Office Action Summary	Application No. 10/723,126	Applicant(s) GILBREATH, DONALD R.	
	Examiner Aaron M. Dunwoody	Art Unit 3679

DETAILED ACTION

Claims 1-5 are rejected under 35 U.S.C. 103(a) as being unpatentable over US patent 6318763, Huang in view of US patent 5709413, Salyers.

FIG. 4

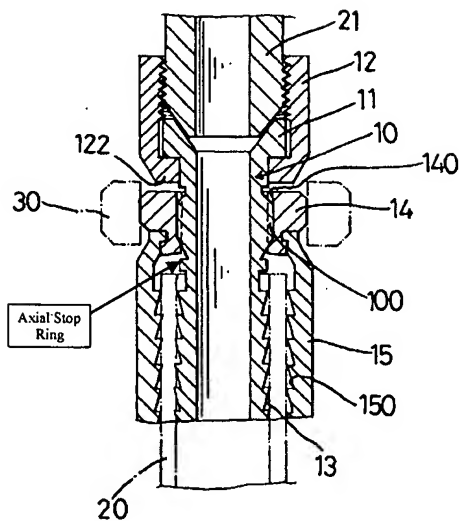
the collar support portion including a *spline* and an axial stop ring (see Figure 4 below),

Applicant argues that Huang fails to disclose at least said collar support portion including an axial stop ring. The Examiner disagrees. As illustrated above, Huang clearly illustrates at least said collar support portion including an axial stop ring.
